...ON/MONROE GREENWAY

...S ONLY

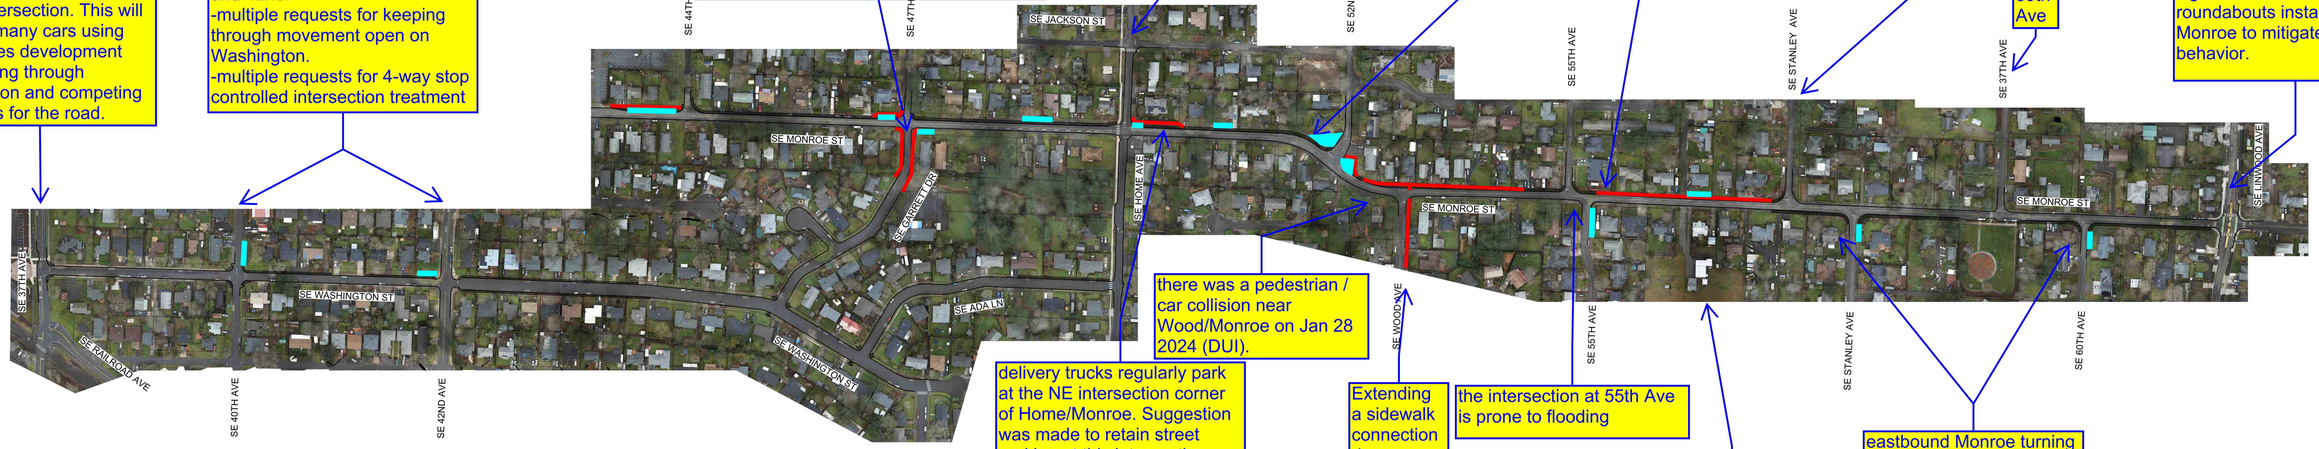
please install a traffic diverter at the Washington Street intersection. This will stop the many cars using the 7-acres development from cutting through Washington and competing with bikes for the road.

please install stop signs at 40th and 42nd.
-multiple requests for keeping through movement open on Washington.
-multiple requests for 4-way stop controlled intersection treatment

Multiple requests to send greenway down Garrett Drive instead of Ada Lane. Reasons include:
- Garrett Drive is shorter route.
- There is already some sidewalk down Garrett to connect into.
- The grade/hill is traversible.
- Cars go faster on Ada and those curves present risk to bikes.

street trees are needed along Home Ave where recent sidewalk was constructed.

speeding is a common problem through the reverse curves at 52nd Ave. it is unsafe for pedestrians to travel through the curves.

there is an old tree that overhangs the road and looks hazardous

"Monroe Cottages" may have sidewalk connection required as a condition of development north on Stanley to bus connection. The project should review those conditions for consistency with current scope.

neighbors have observed that the traffic diverter installed at Linwood is causing traffic to take side streets at a high rate of speed. neighbors prefer to see 4-way stop signs on Monroe or roundabouts installed on Monroe to mitigate this behavior.

there was a pedestrian / car collision near Wood/Monroe on Jan 28 2024 (DUI).

delivery trucks regularly park at the NE intersection corner of Home/Monroe. Suggestion was made to retain street parking at this intersection.

semi-trucks use Home as route. consider this into design for traffic circles at Home/Monroe.

Extending a sidewalk connection down Wood ave makes sense for a short distance to reach existing sidewalk

the intersection at 55th Ave is prone to flooding

there is a >40 unit development planned at "Monroe Cottages" here, which has completed their own traffic study. The project should review that study for consistency with current traffic scope.

eastbound Monroe turning southbound on Stanley and 60th have a high rate of speed. sidewalk on the south side as shown will improve sight distance at these intersections.
